**CITY OF NAPOLEON - BUILDING DEPARTMENT**

RESIDENTIAL PLAN CORRECTION SHEET

Re: 955 Harmony Drive

FIELD CORRECTION NOTICE

SITE PLAN

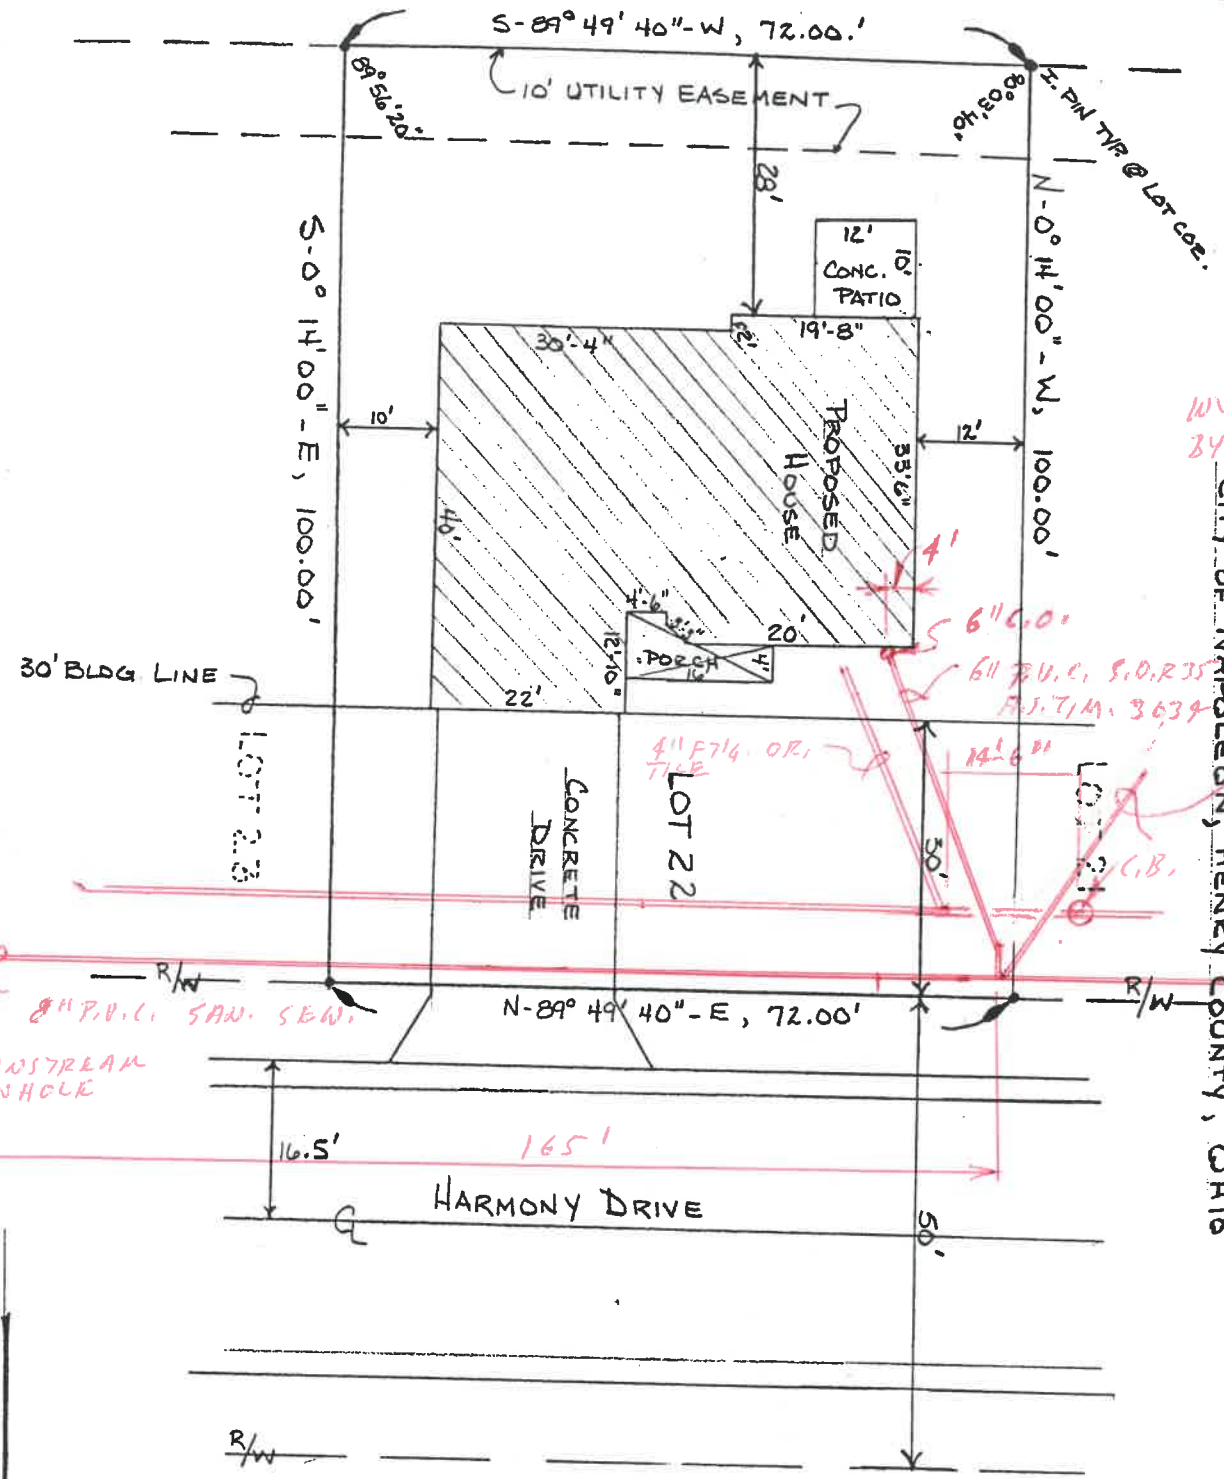
\* SIDEWALK TO BR SHOWN  
ON SITE PLAN

\* CHECK SUPPORT OF TOP PLATE  
BACK WALL VAULTED CEILING AREA

EMER EXITS O.K.

FLOOR GIRDER

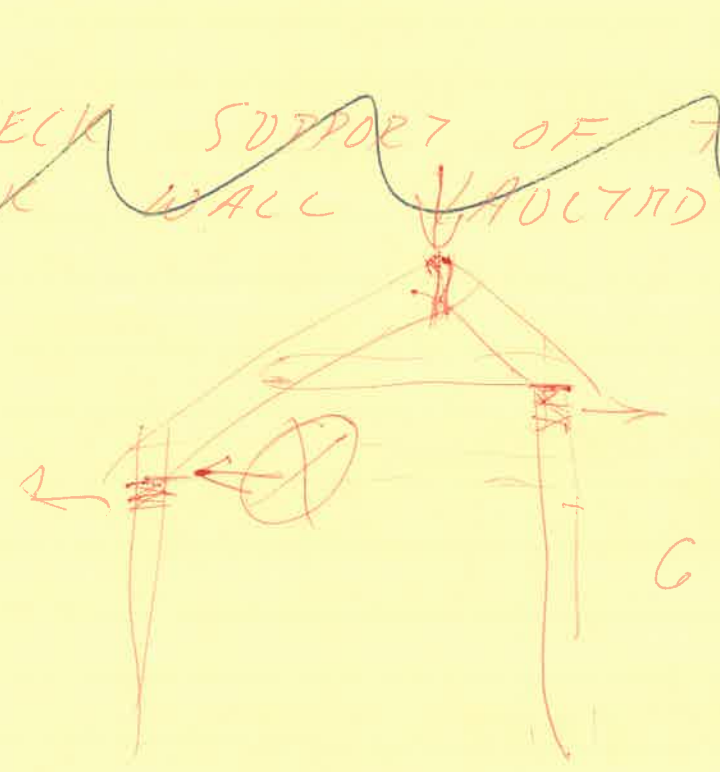
10'-6" x 40+10+20+10 = 80 # P.S.F.

$$\frac{840 \times 7 \times 7 \times 12}{8} = 61740$$

$$\frac{840 \times 5'-8" \times 5'-8" \times 12}{8} = 40,507$$

$$S = \frac{bd^2}{6} = 64117$$

3-2x10 BRAN OK @ 7'-0" SPAN

2-2x10 BRAN OK @ 5'-8" SPAN

SITE PLAN  
 RIVERBEND CONSTRUCTION  
 LOT No. 22, PHASE I BRICKYARD SUBDIVISION,  
 CITY OF NAPOLEON, HENRY COUNTY, OHIO

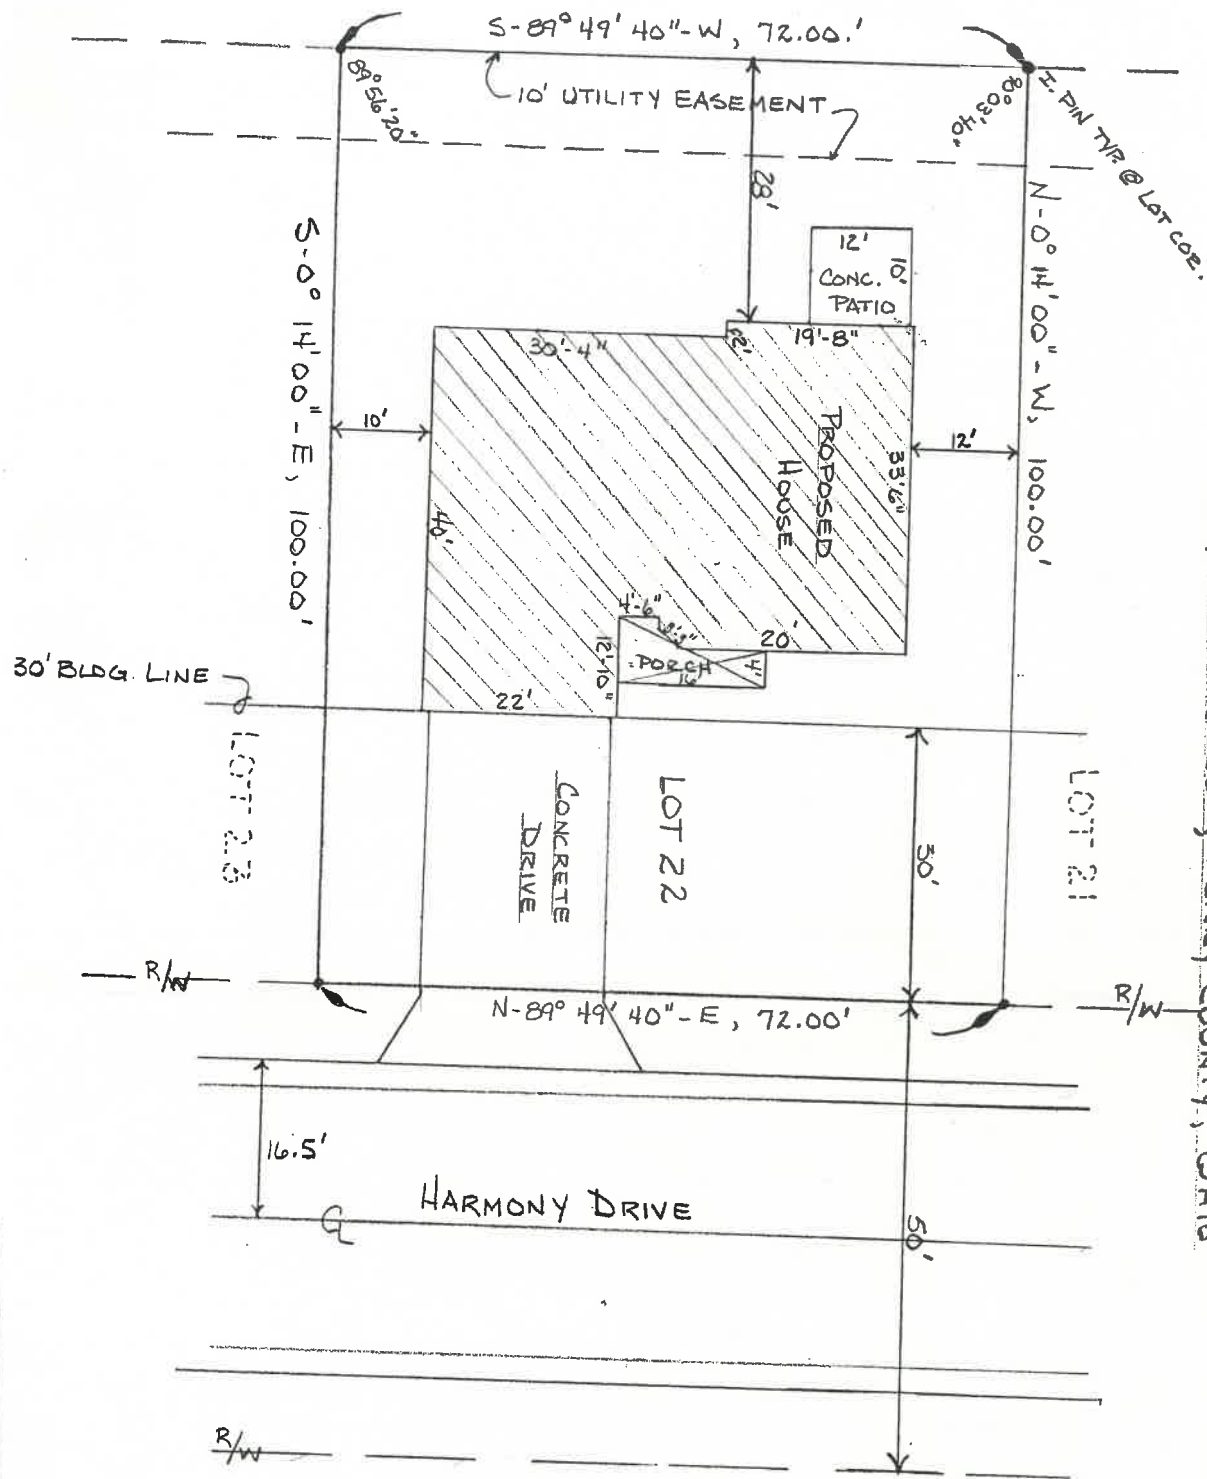
- 1) Provide design for vaulted ceiling area framing. Including an engineers stamp if the framing method includes a ridge beam in its present location approximate 3' from the garage bearing wall.
- 2) Show the sidewalks on the site plan 4' wide 1' from the property line. Line & grade for these walks and for the driveway to be approved by the City Engineering Department.
- 3) Have your Sub-Contractors apply for their permits, electrical, plumbing, mechanical. Please clarify with them who is to pay the \$300.00 water tap charge, the \$60.00 sewer tap inspection fee and the \$225.00 underground electrical charge.
